MEMORANDUM

SUBJECT: EPA Alternative Post-Injection Site Care (PISC) Review Memorandum for the Marquis Class VI permit– Permit Number IL-115-6A-0001; Putnam County, IL

Summary

Figure 2-16: Model Zones and corresponding gamma ray, resistivity, and porosity logs. The Mt. Simon layers are considered reservoir, while the upper Elmhurst and Eau Claire shale act as the seal (A.R. #964).

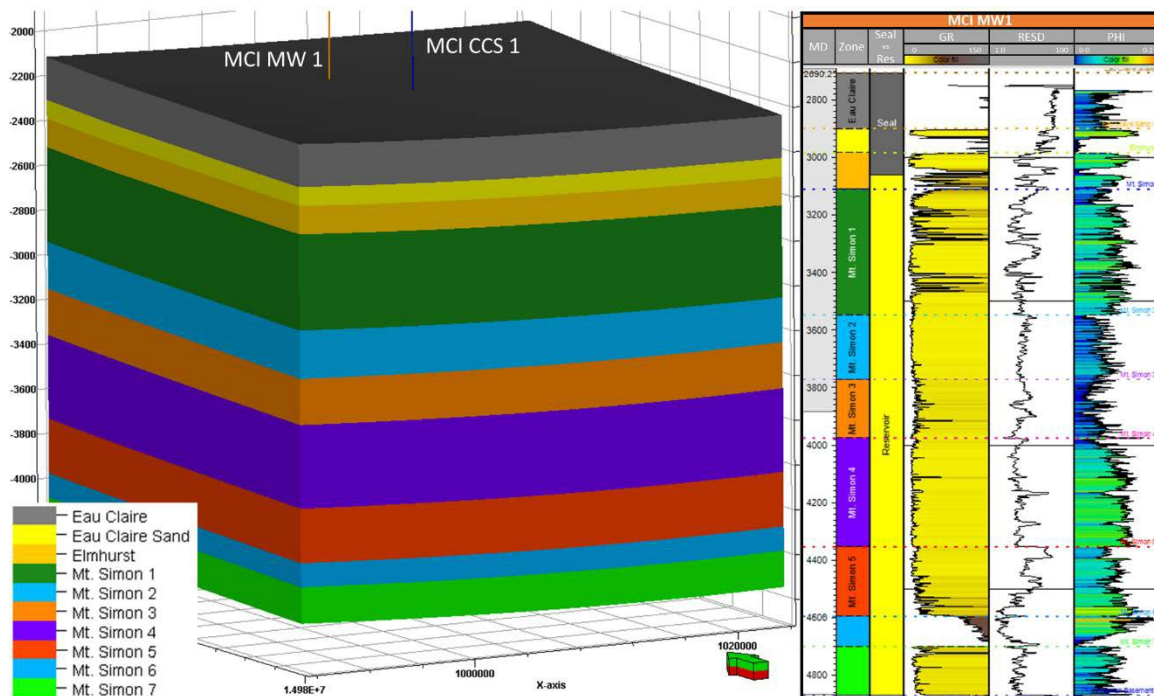
Marquis' alternative PISC timeframe demonstration included site-specific data for the confining and injection formations of the project when determining the potential for structural or stratigraphic trapping at the project. Structural trapping is a primary trapping process that occurs during injection and storage due to the site-specific physical properties of the formations. Those properties for the Eau Claire Formation are the fact that it consists primarily of shale and acts as a confining layer. The physical properties of the Mt. Simon, which is primarily sandstone, provide ample pore space for storage.

The Mt. Simon is heterogeneous, meaning it is largely composed of sandstone, but does contain other rock types. As demonstrated via the site-specific data, there will be some less porous space in the Mt. Simon that will cause CO₂ to not be trapped at the same rate as in sandstone. However, the model shows the percentage of CO₂ that is not physically trapped by the sandstone will continue to reduce over time. See A.R. #1542 at Figure 9.3.
